## CORRIGENDUM - 02 TO NIT NO-99017

**Subject: Corrigendum-02 to Tender enquiry for Pre-Bid Tie up with the GIS OEM for Supply & Services of 765kV GIS Pkg for POWERGRID's Substation Package SS-147T (Pendurthi & Srikakulam) Tender / Project.**

**Amendment No. II (Technical)**

**Clarification-I (TECHNICAL)**

**TITLE :**  
STANDARD 765 kV GIS  
BUILDING ARCHITECTURAL  
DRAWING (PLAN)

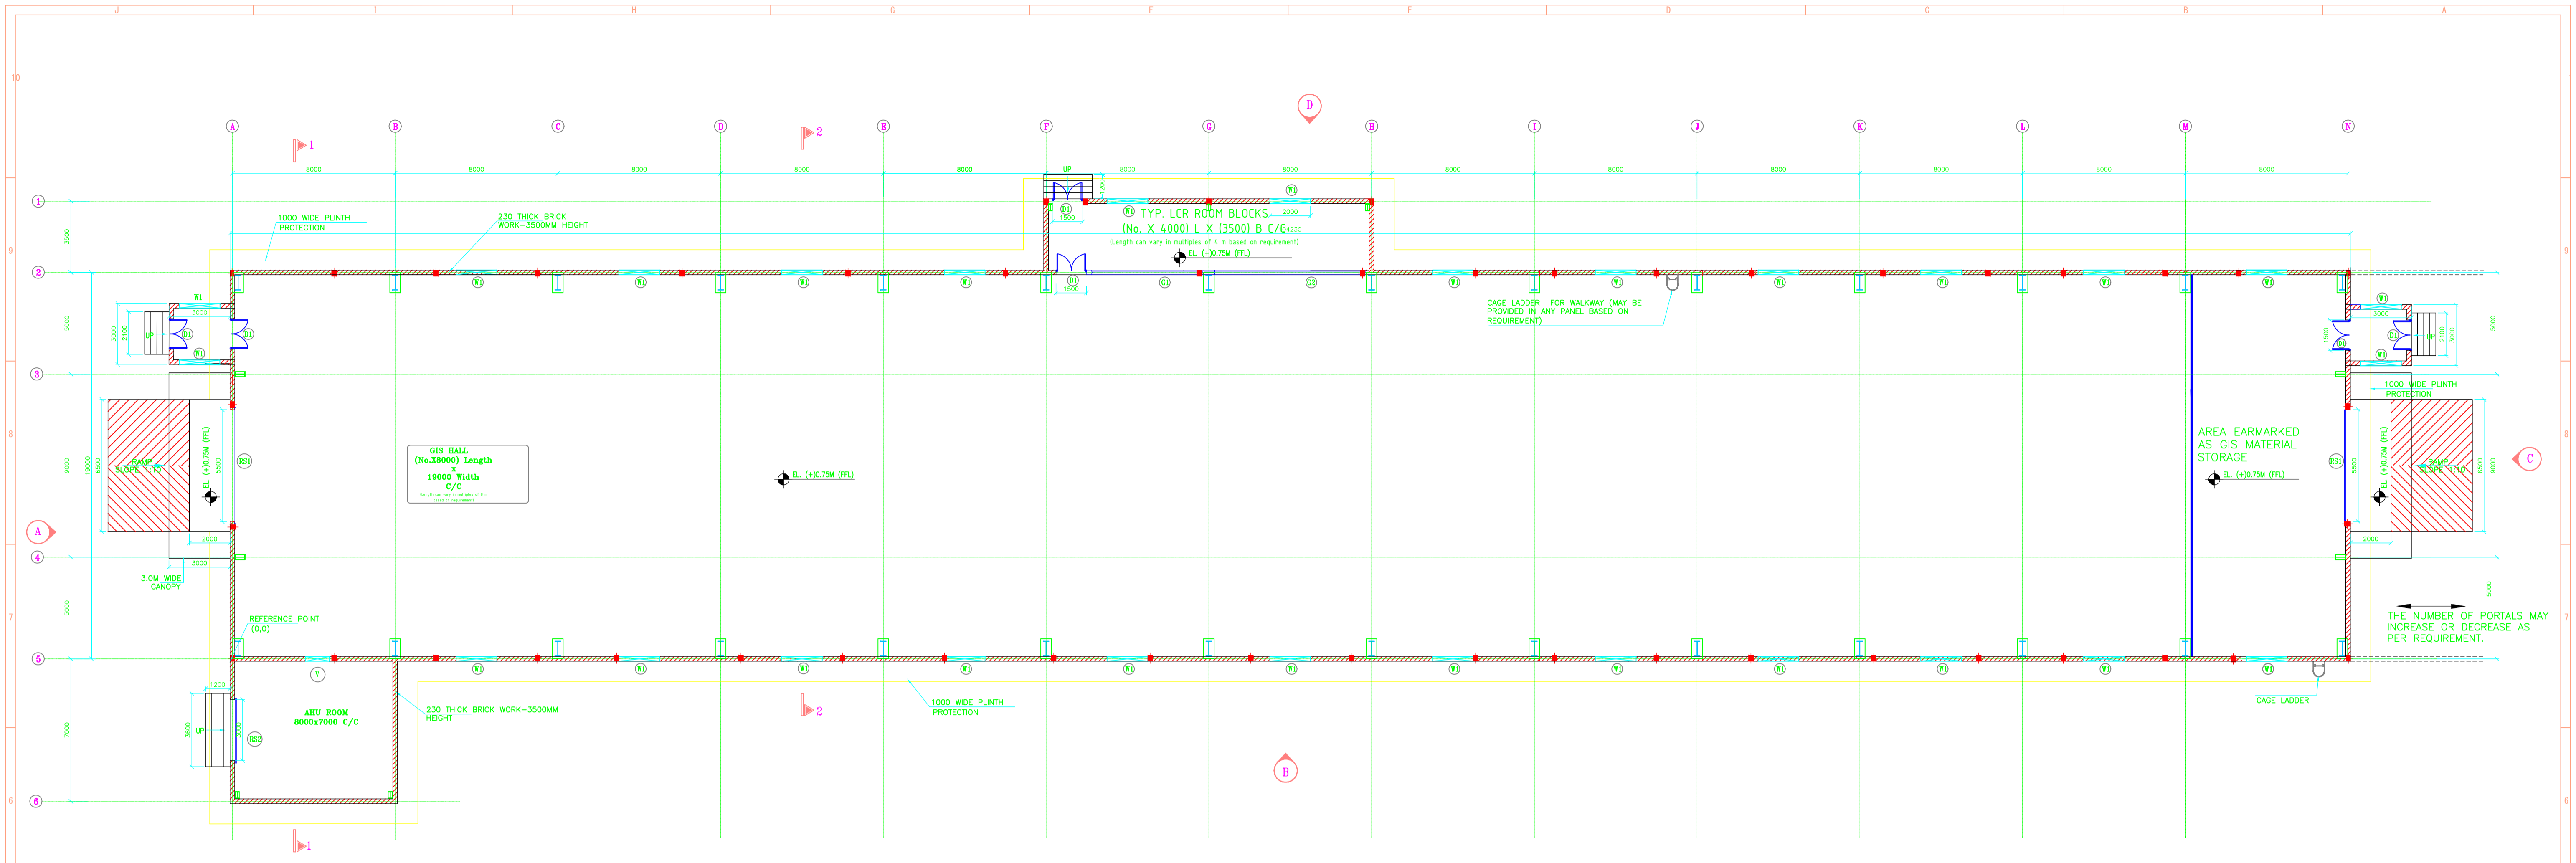
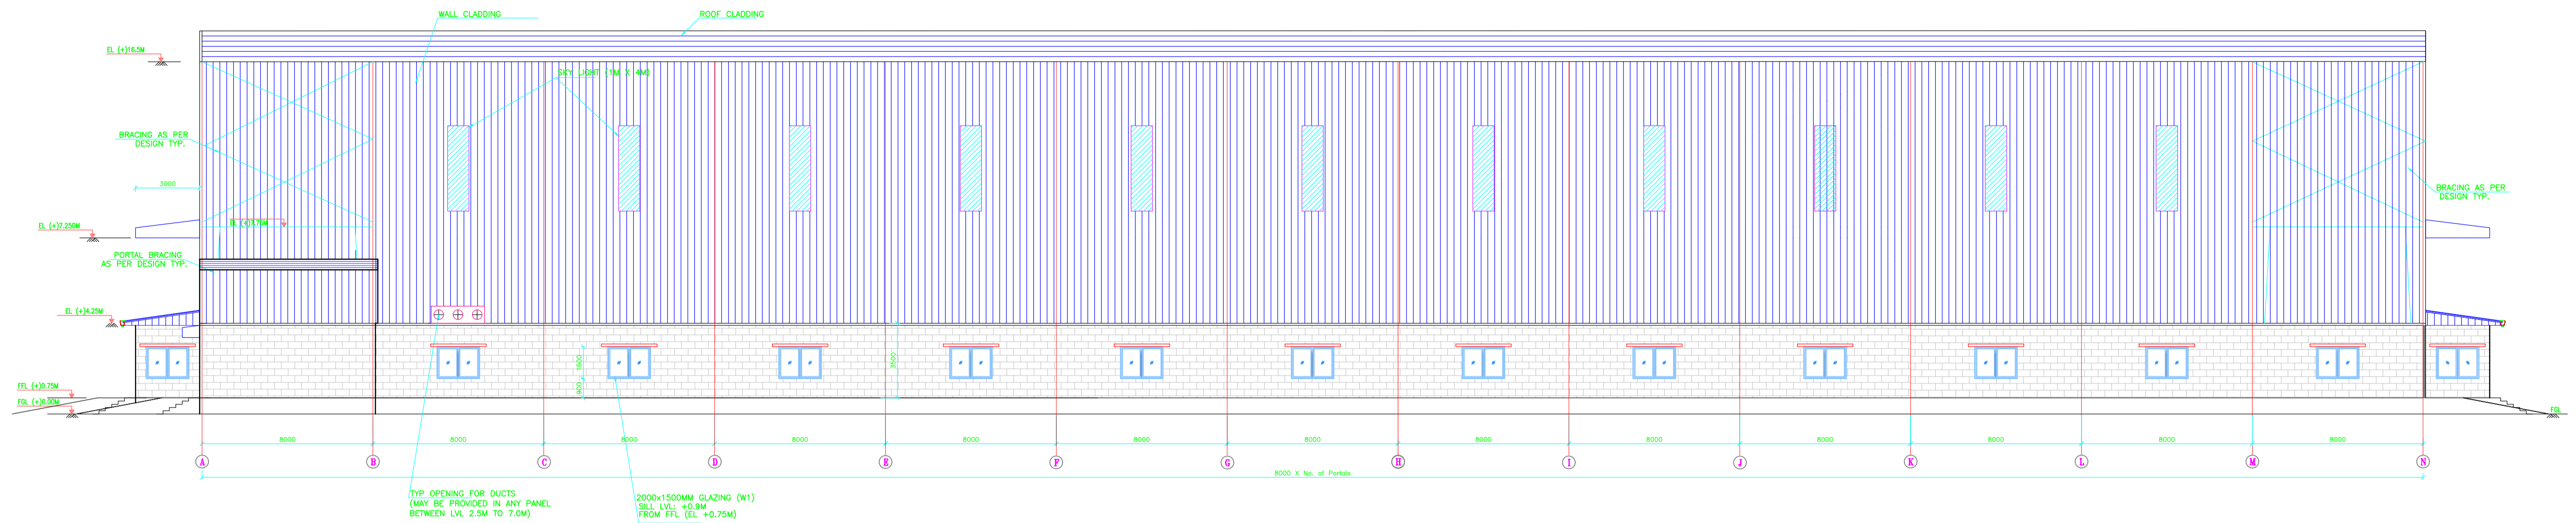
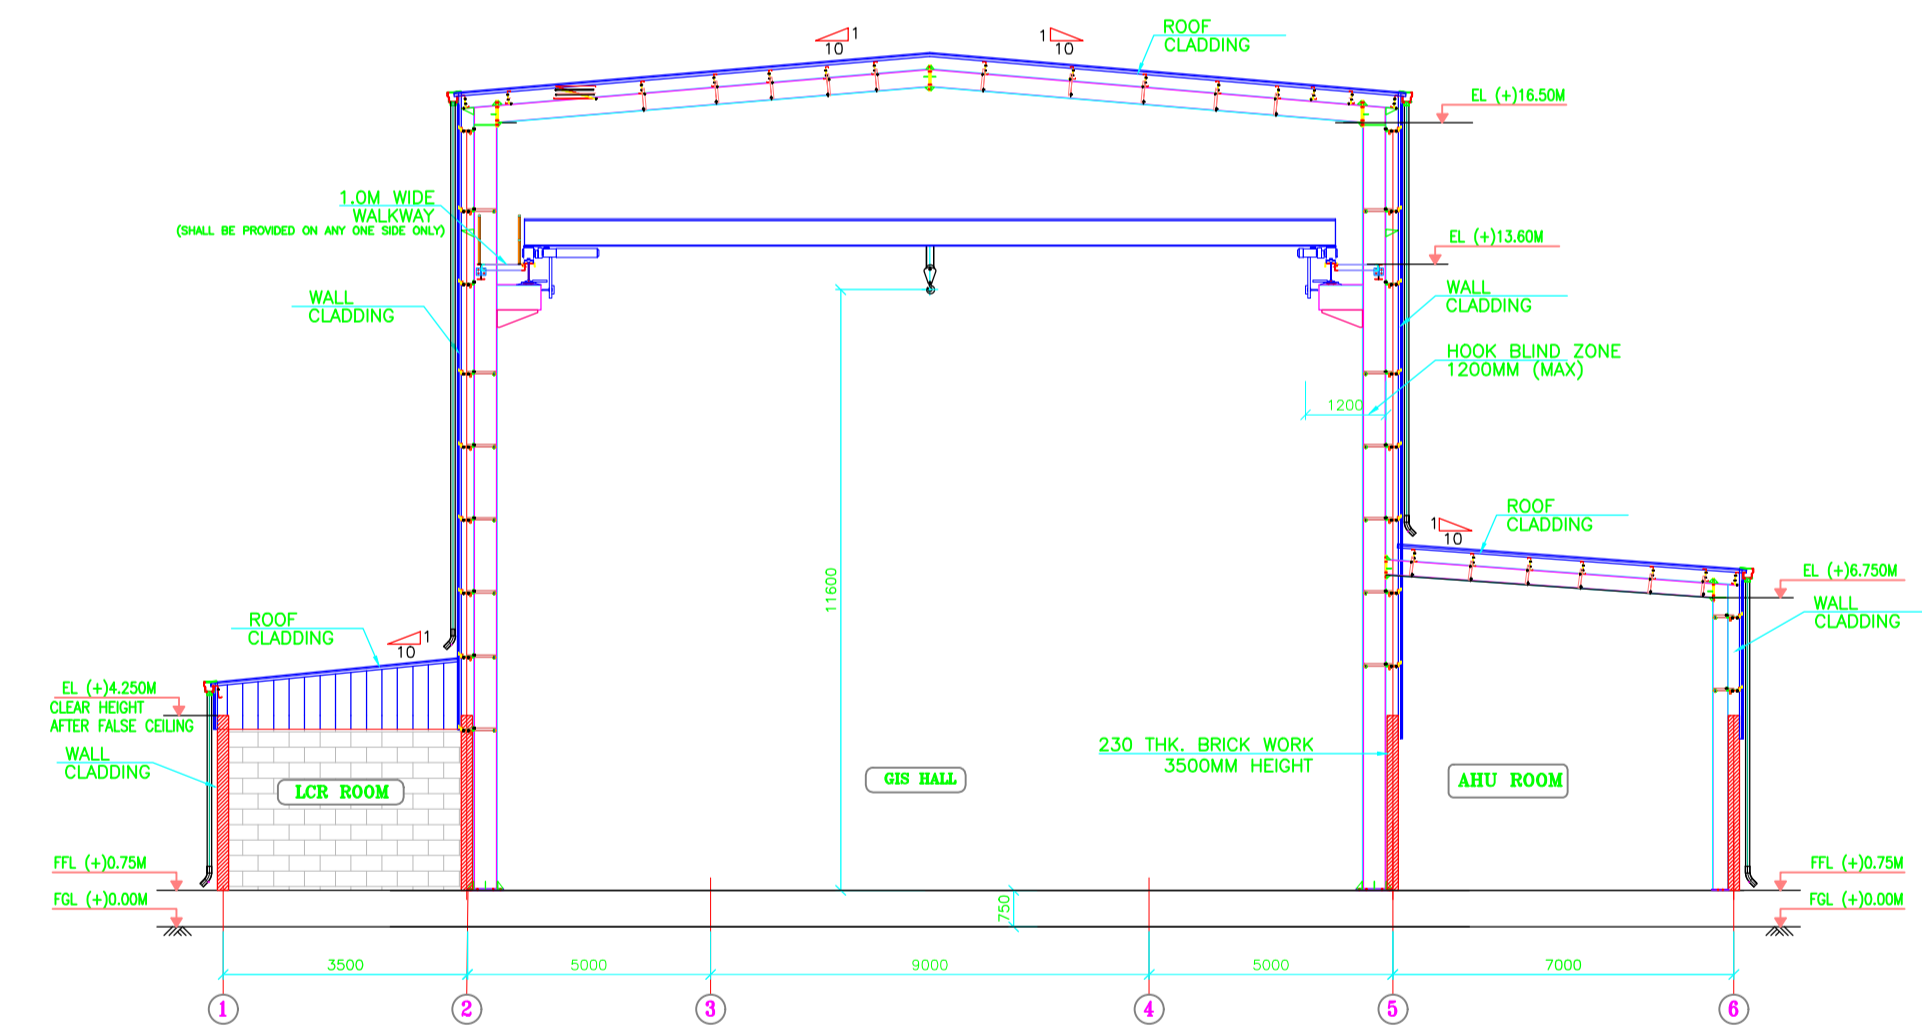
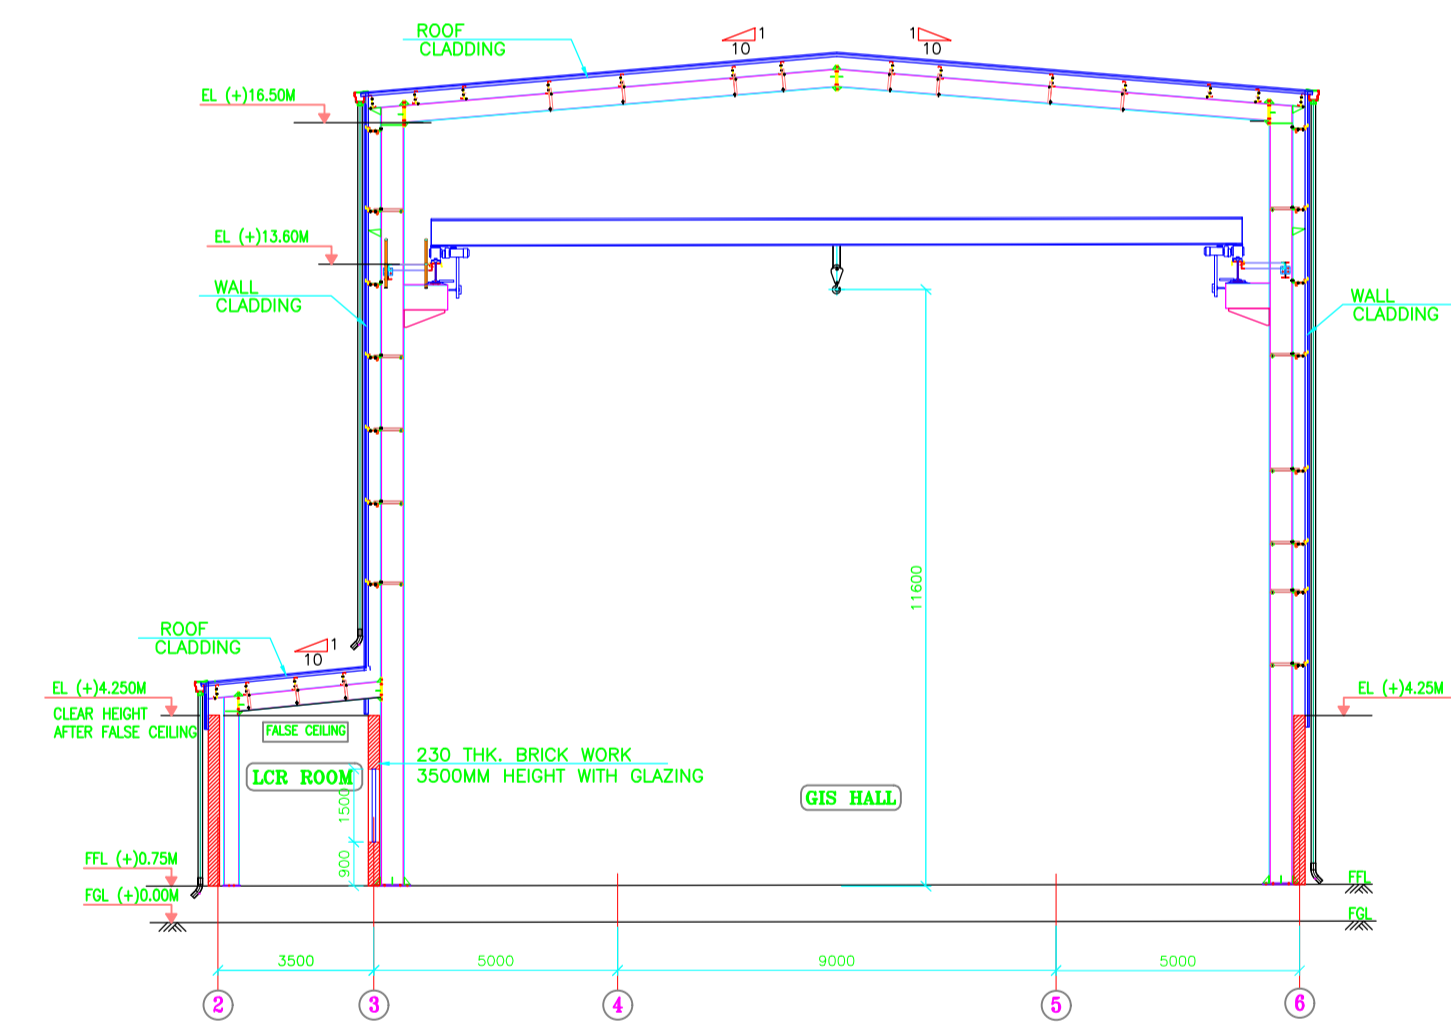
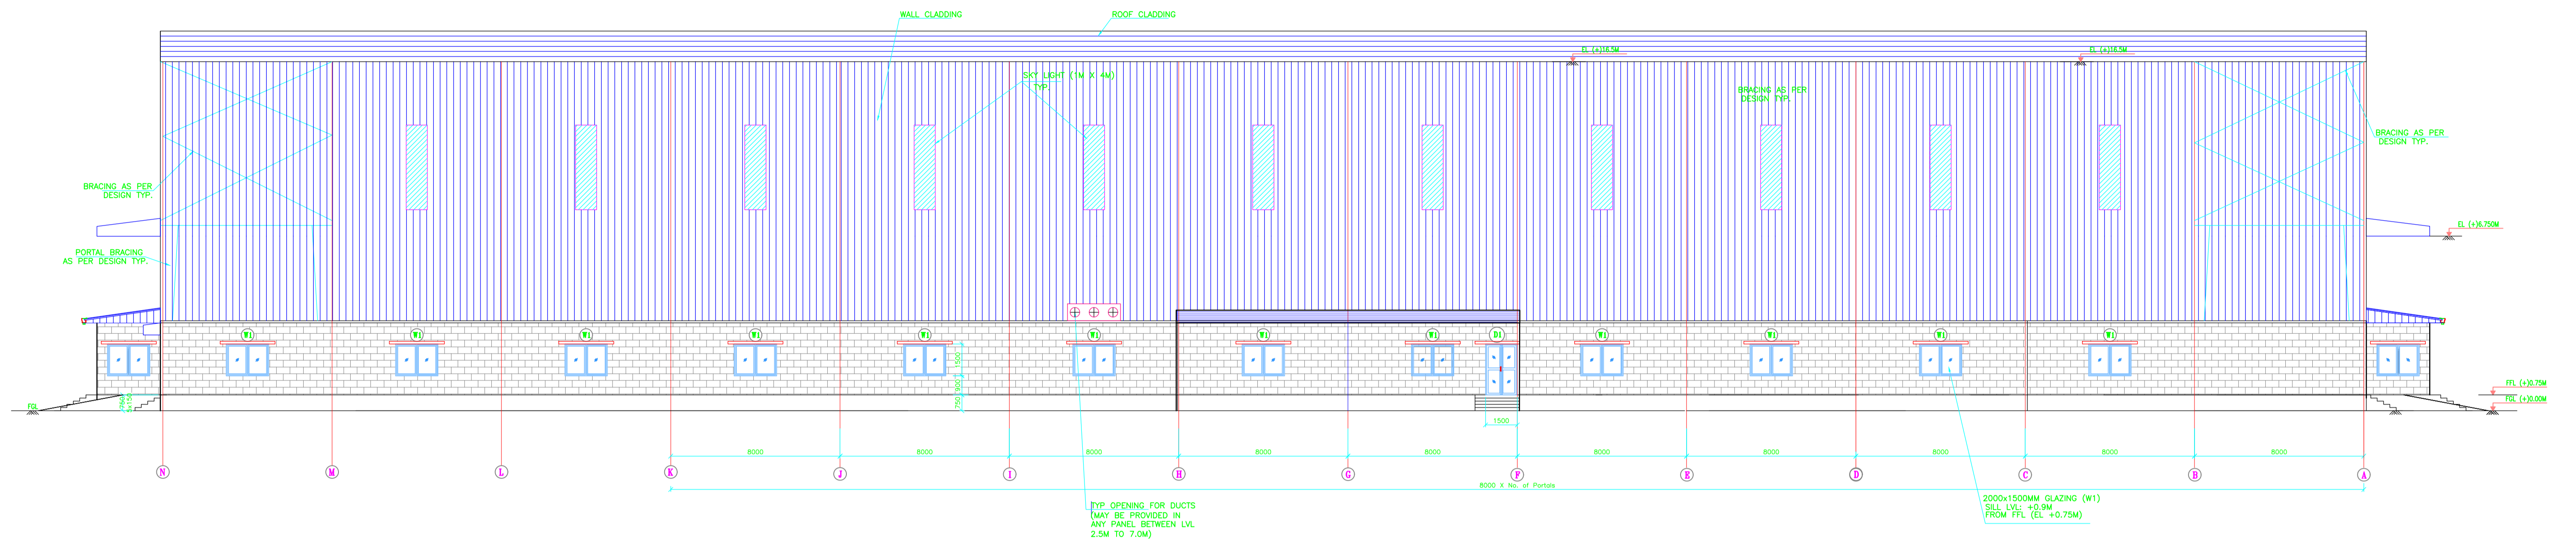
Sr. No.	Drawing No.	Description	Rev																														
<b>Electrical Drawings</b>																																	
2.	C/ENGG/CIVIL/765KV/GIS/ARCA/H/DRW/01	STANDARD 765kV GIS BUILDING ARCHITECTURAL DRAWING	R0																														
<b>Drawings of Existing Substations</b>																																	
Sr. No.	Drawing No.	Description																															
<b>765kV Srikakulam GIS SS</b>
